PROJECT NUMBER: SP2024-013
PROJECT NAME: Site Plan for 1780 Airport Road
SITE ADDRESS/LOCATIONS: 1780 AIRPORT RD, ROCKWALL, TX 75087

CASE CAPTION: Discuss and consider a request by Jeff Carroll of Jeff Carroll Architects, Inc. on behalf of Margie Verhagen of Meals on Wheels for the approval of a Site Plan for a facility for a Social Service Provider (i.e. Meals on Wheels) on an 6.211-acre tract of land identified as Tract 2 of the D. Harr Survey, Abstract No. 102, City of Rockwall, Rockwall County, Texas, zoned Light Industrial (LI) District, situated within the Airport Overlay (AP-OV) District, addressed as 1780 Airport Road, and take any action necessary.

03/22/2024: SP2024-013; Site Plan for 1780 Airport Road
Please address the following comments (M= Mandatory Comments; I = Informational Comments)

TO: Planning and Zoning Commission
DATE: April 30, 2024
APPLICANT: Jeff Carroll; *Jeff Carroll Architects, Inc.*
CASE NUMBER: SP2024-013; *Site Plan for 1780 Airport Road*

SITE PLAN

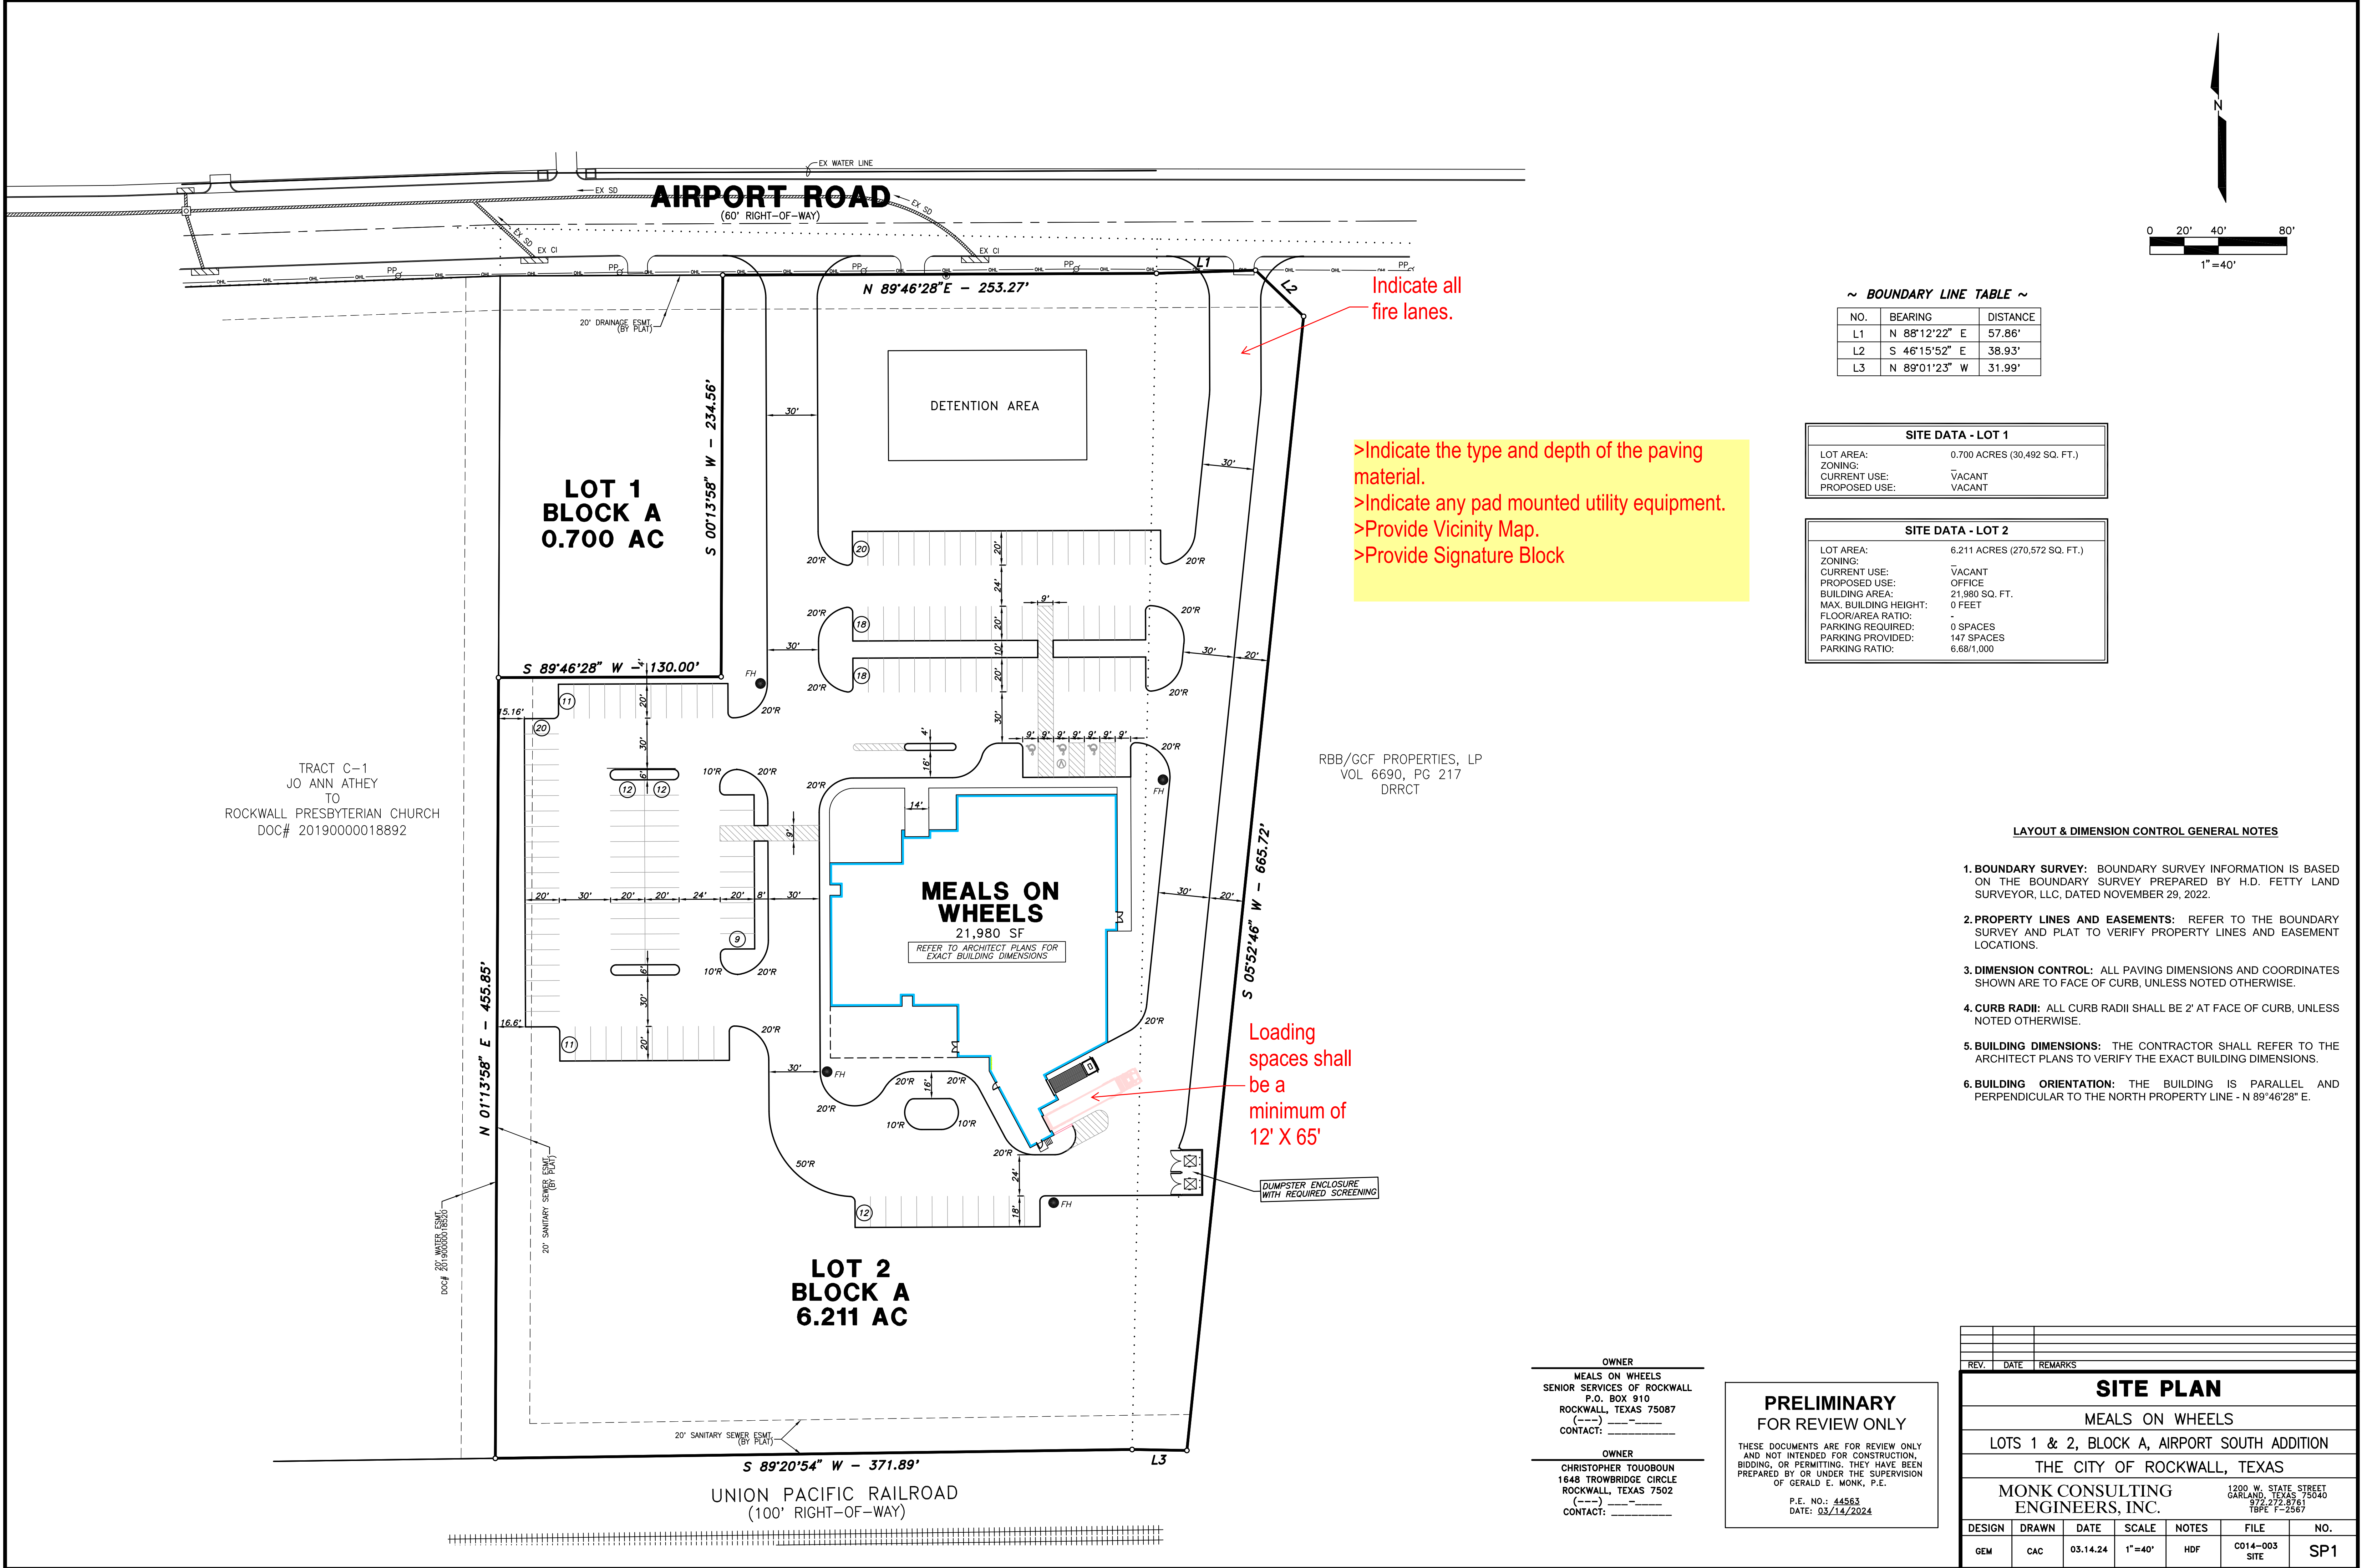
- M.6 Provide a letter from the FAA confirming compliance.
- M.7 Site Plan
- 1) Provide a vicinity map. (Subsection 03.04, of Article 11, UDC)
 - 2) Cross access needs to be provided to the adjacent parcel of land (i.e. Lot 1, Block A). This can be achieved by moving the driveway over between the two (2) properties or providing an access easement to the driveway.

SHEET NO:
A501

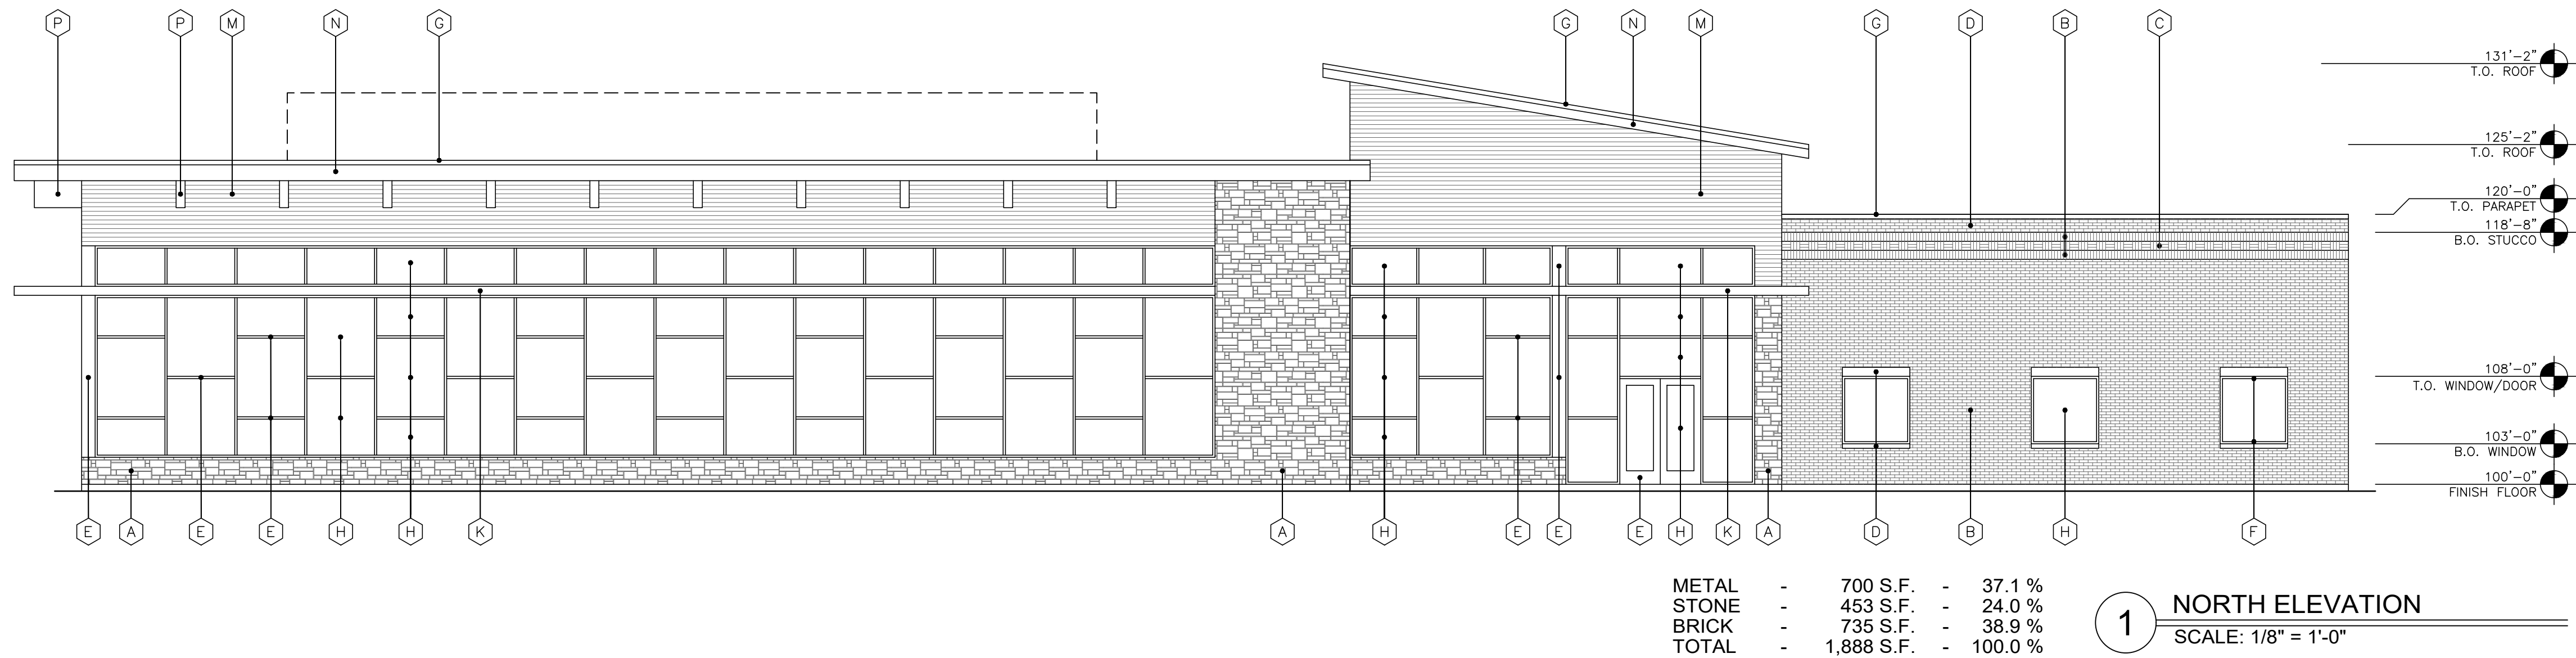
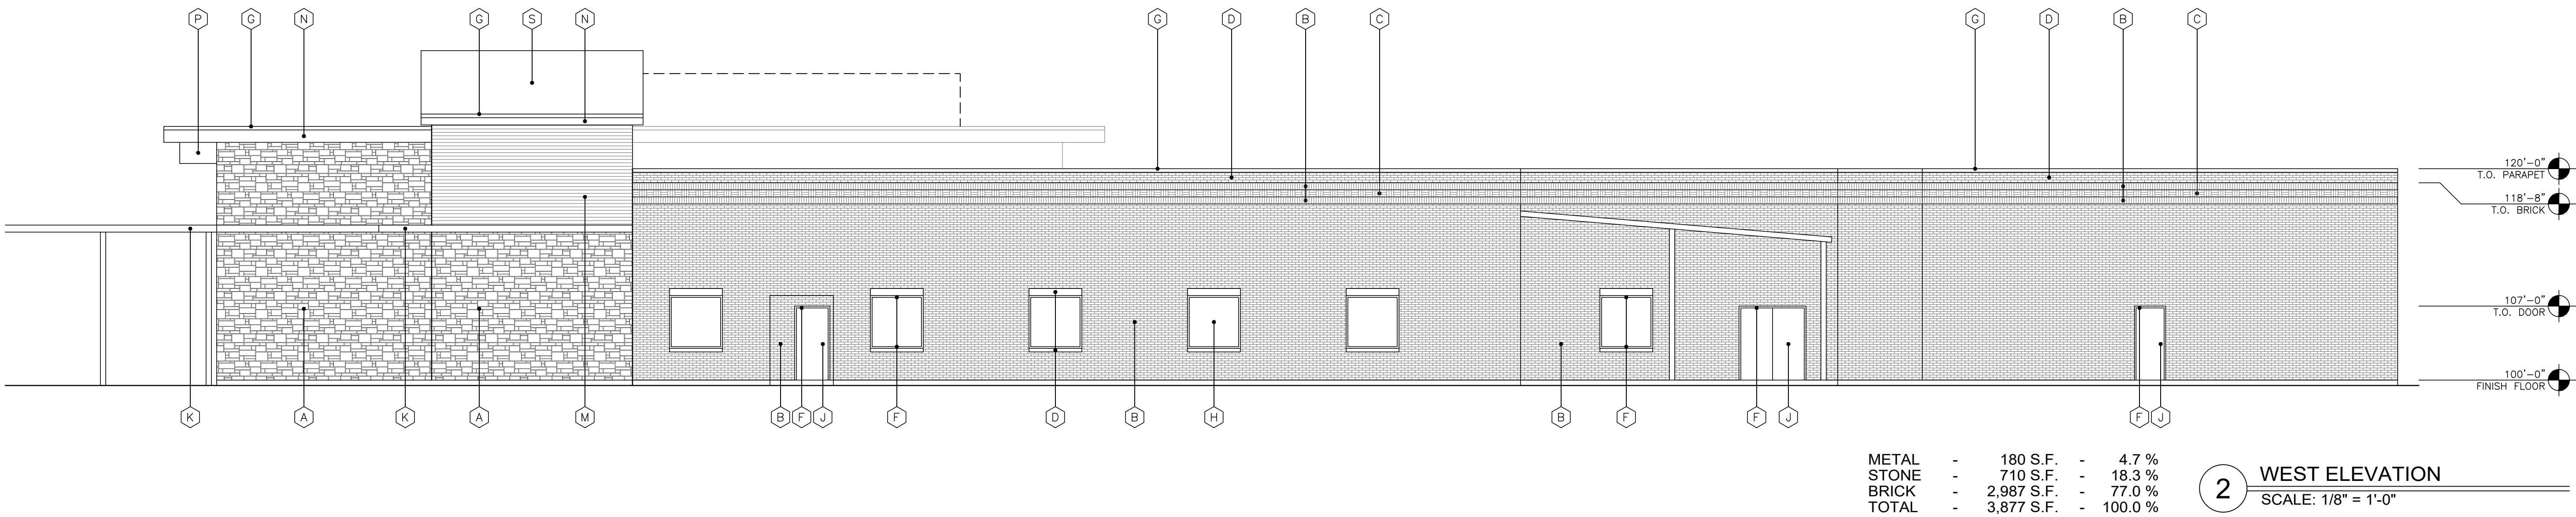
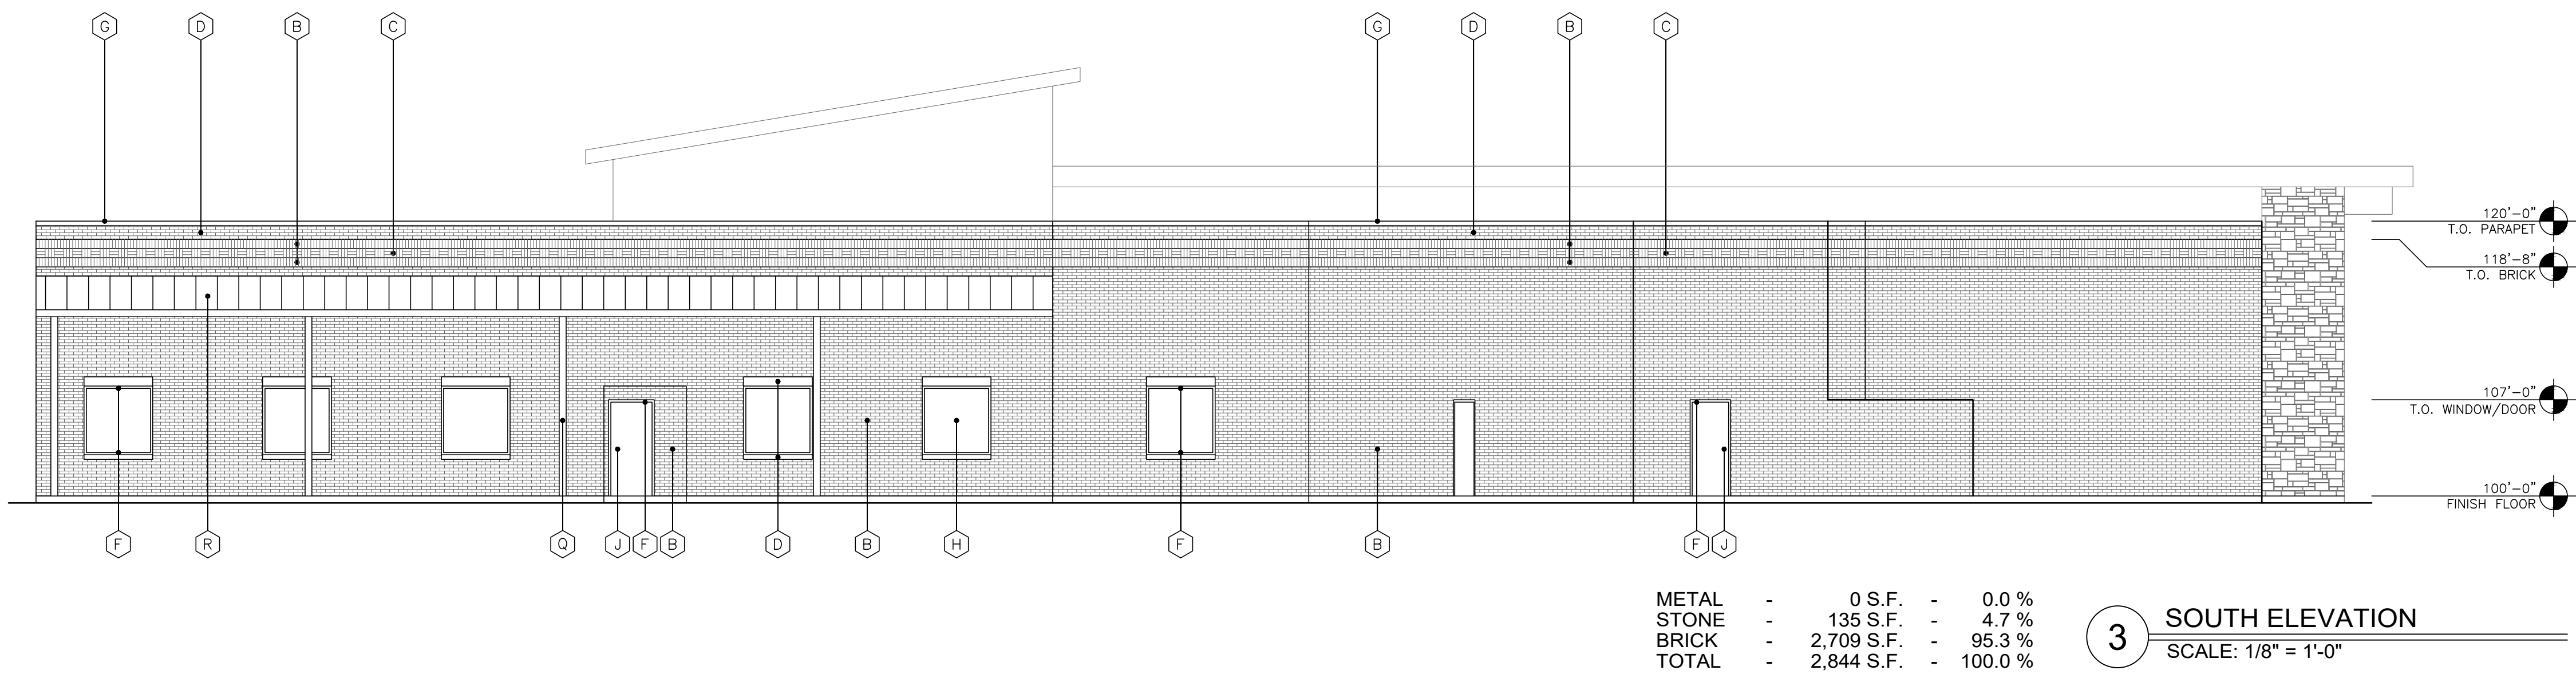
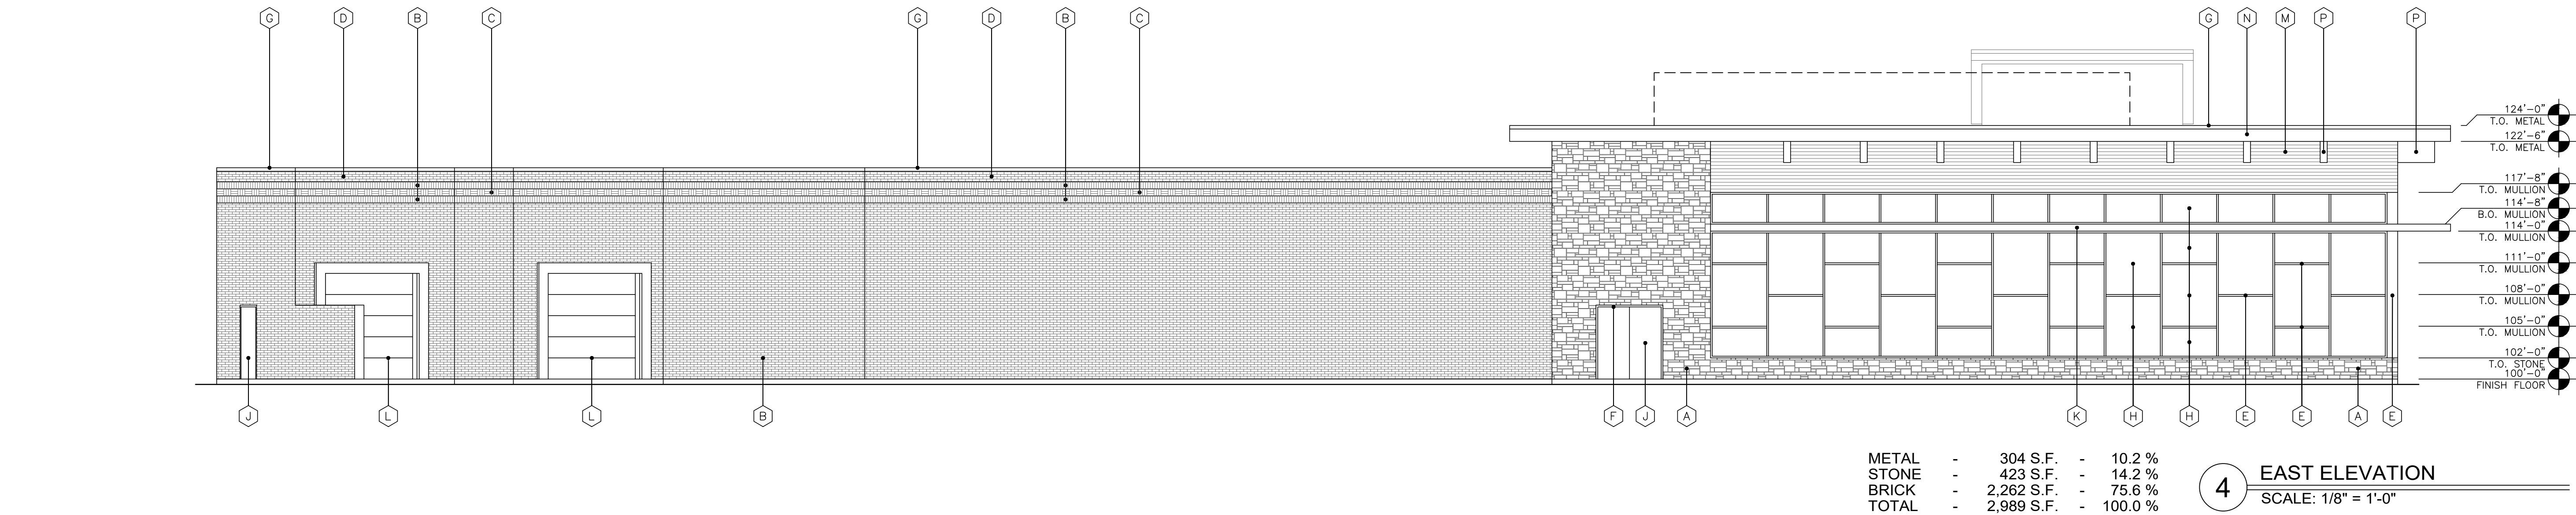
>Indicate RTUs and how they will be screened.
>Primary and Secondary facades do not meet articulation standards specifically wall length requirements. (Exception)
>Does not meet 20% Stone requirement (Exception)
